Project No. 2021\_154

MIDLOTHIAN ISD STADIUM ADDITIONS AND RENOVATIONS

ADDENDUM NO. 2

DATE: October 18, 2021

SHEET NUMBER  
**S-201**

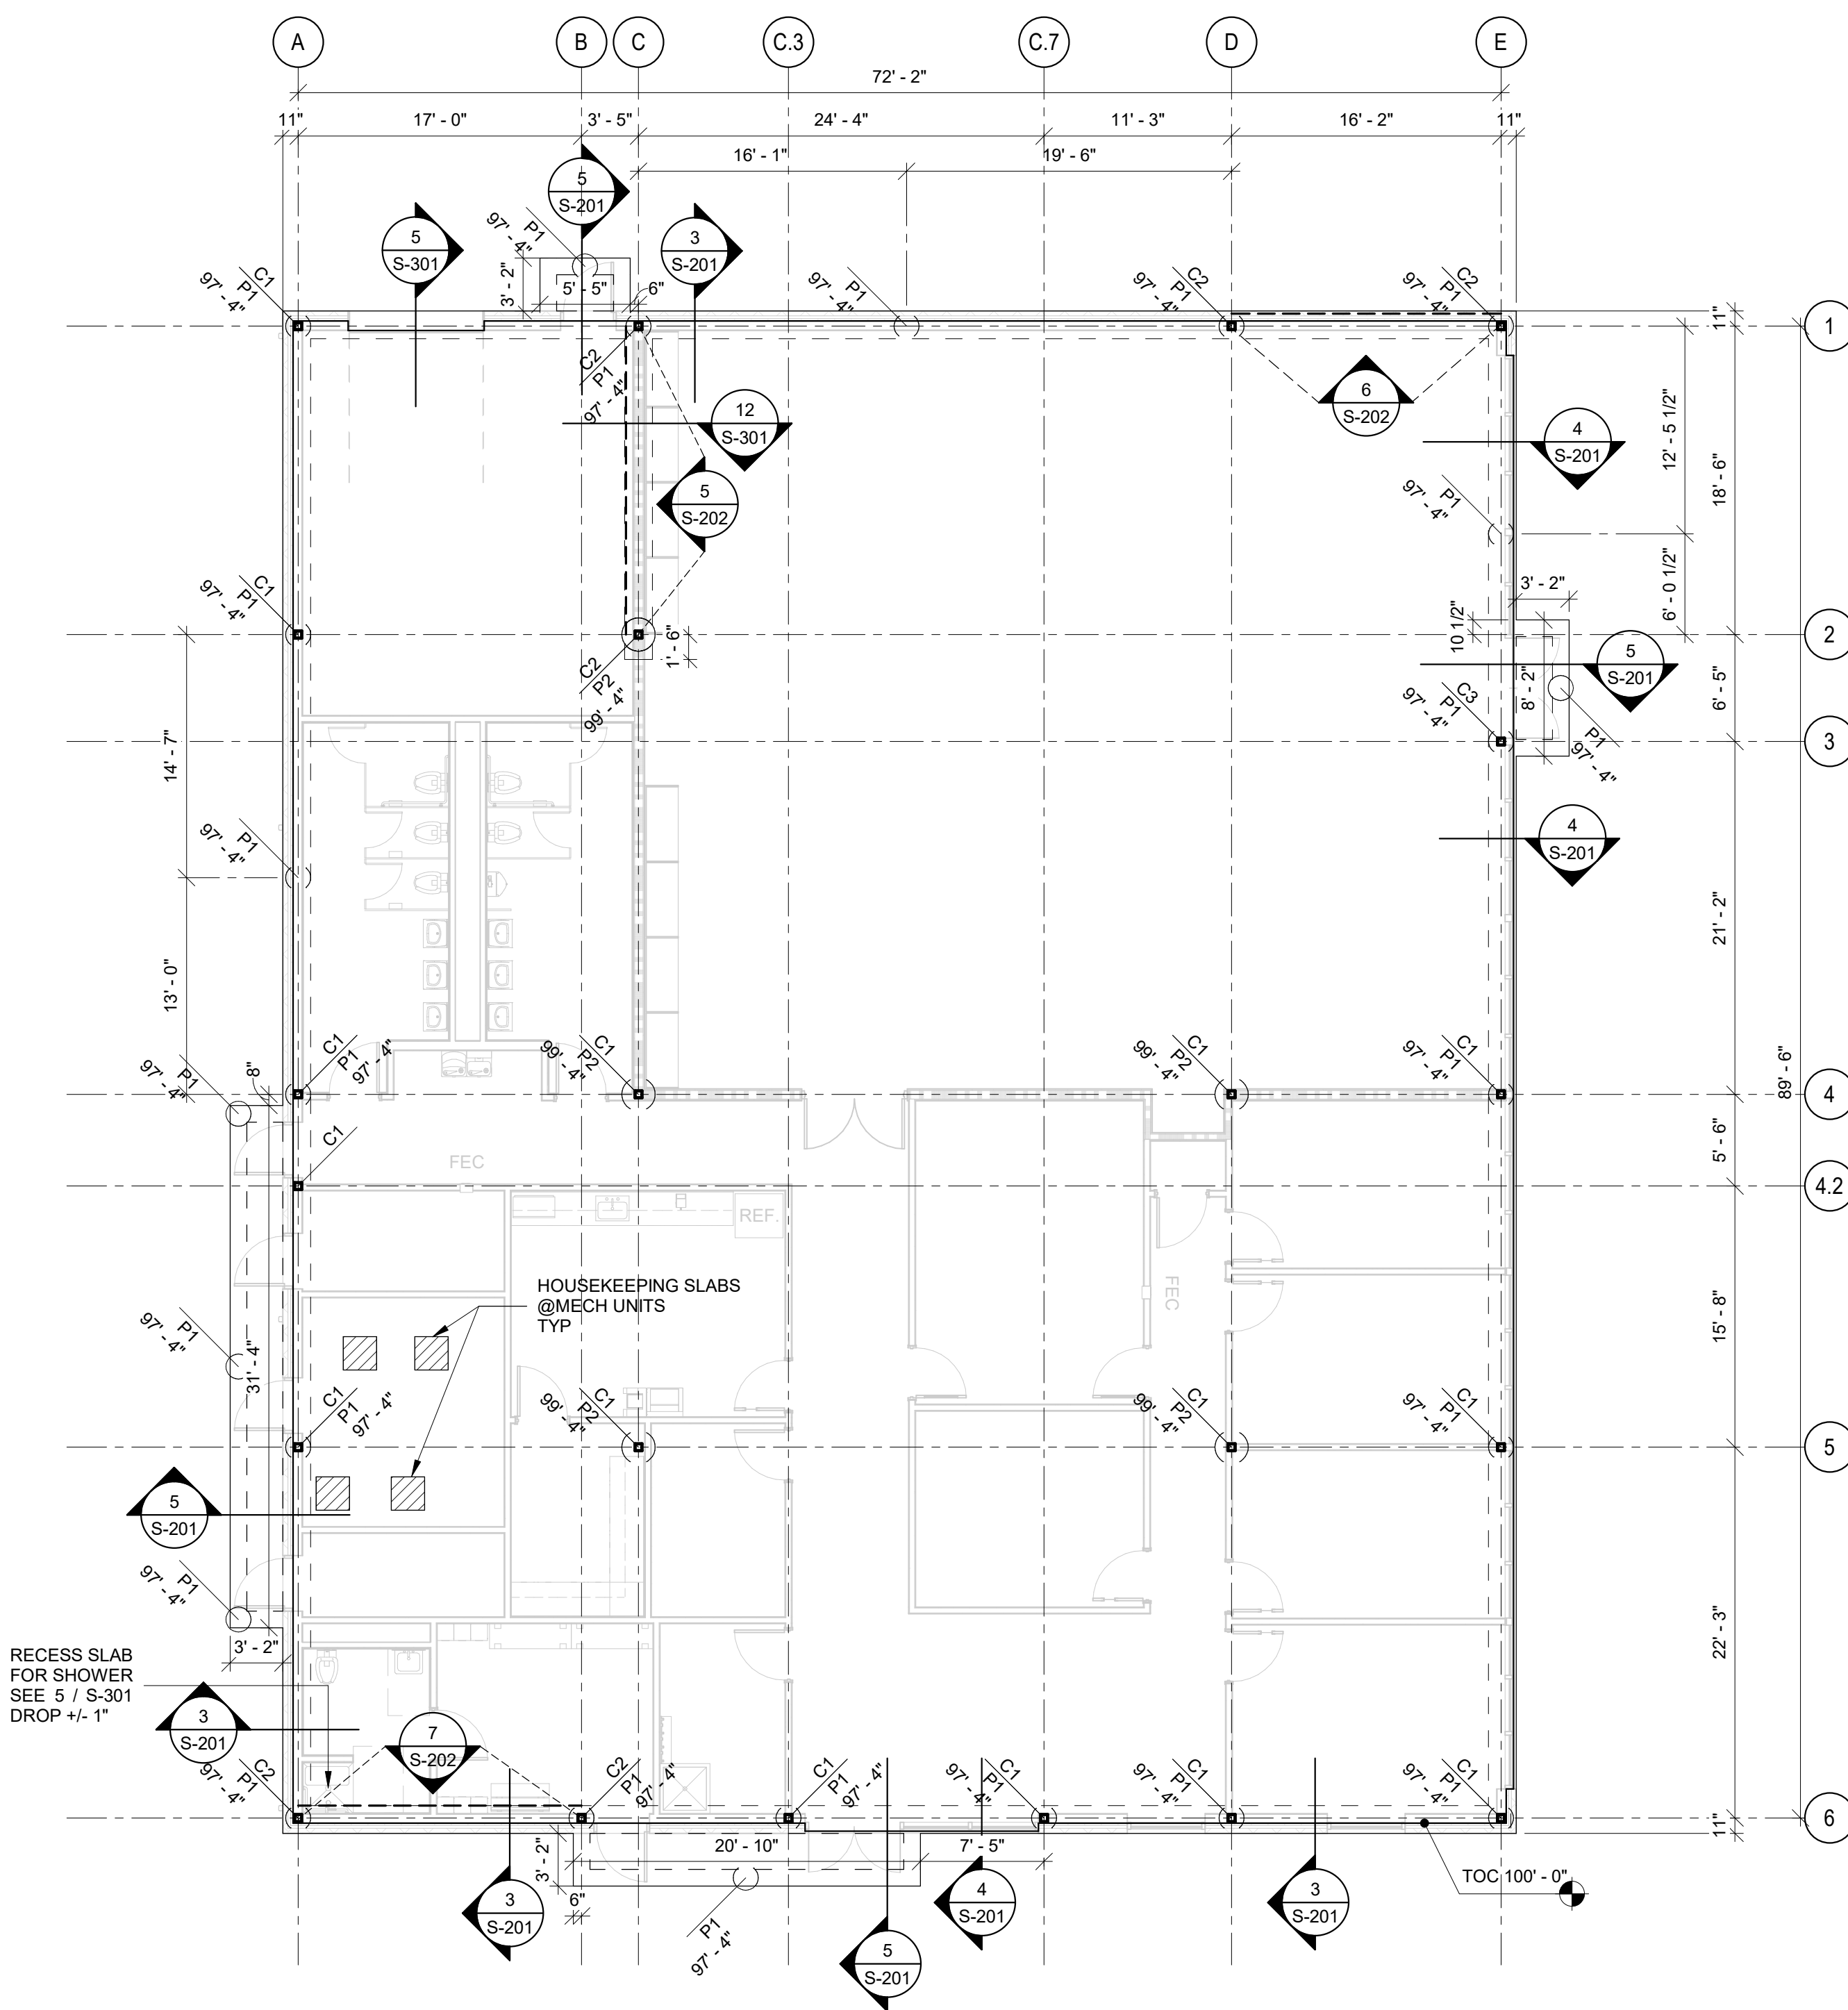
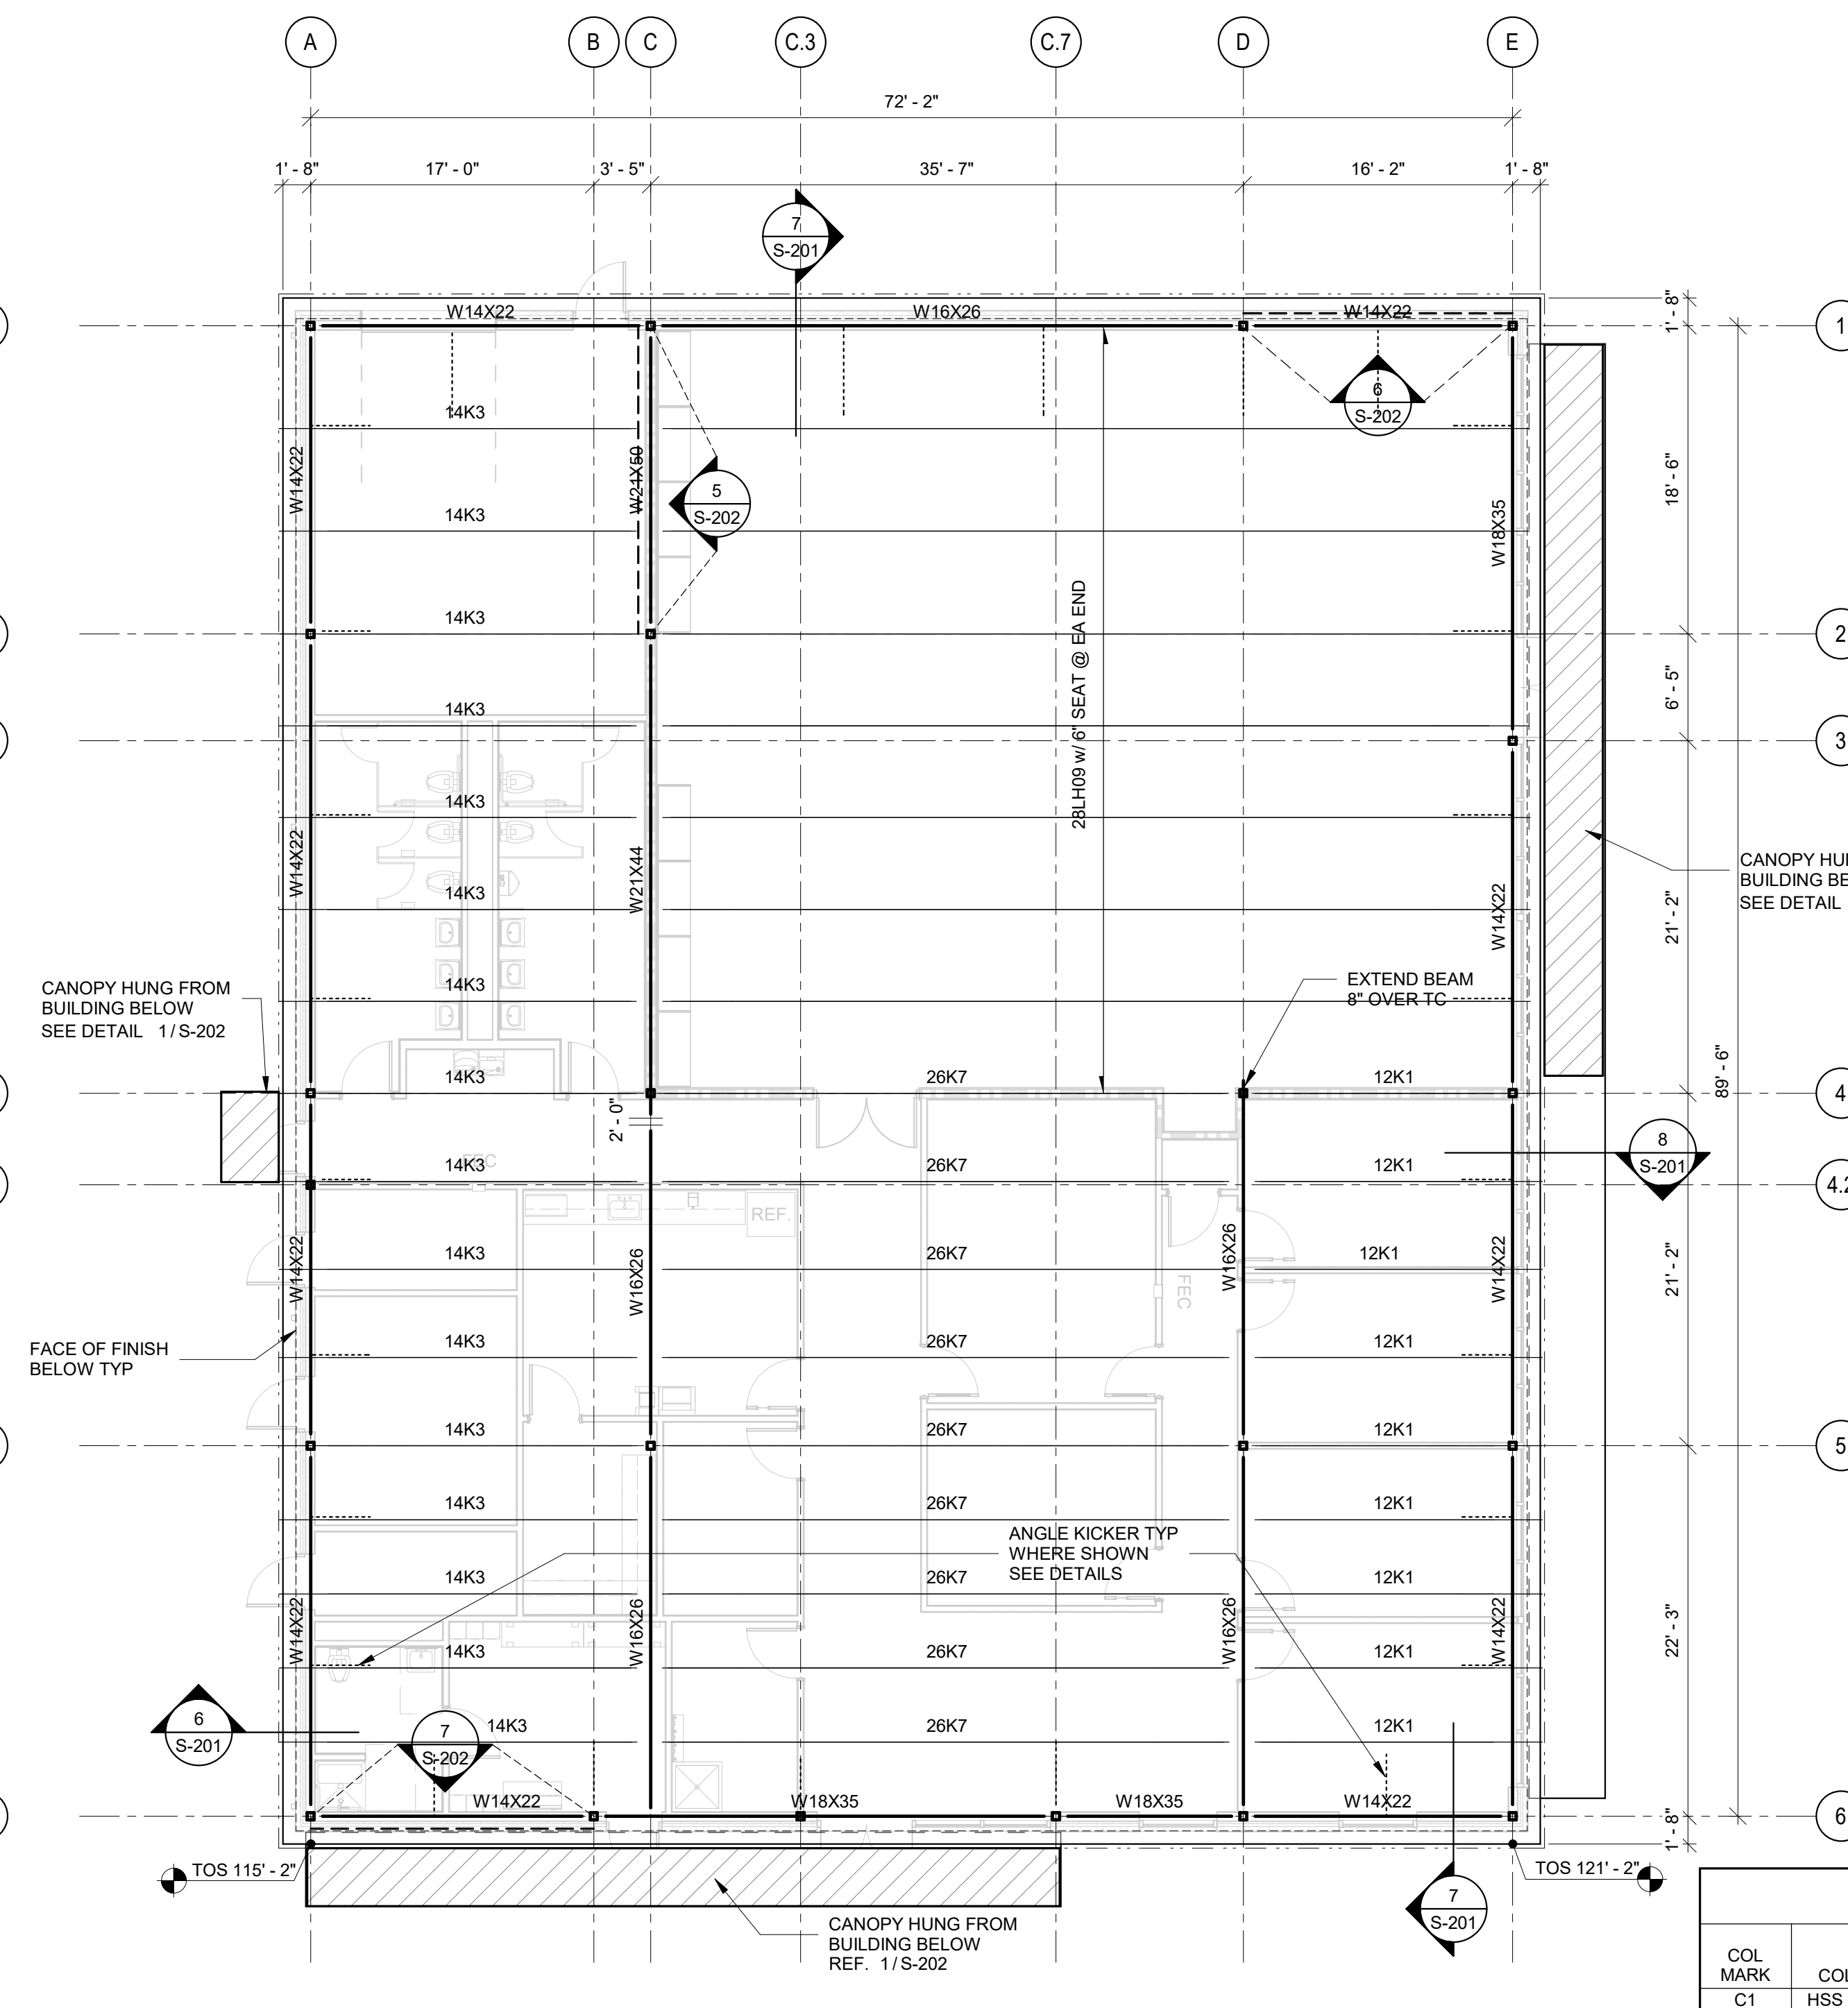
- a. 5/ S-201 Compressible filler at building REMOVED
- b. Drilled Pier Notes UPDATED for Alternates
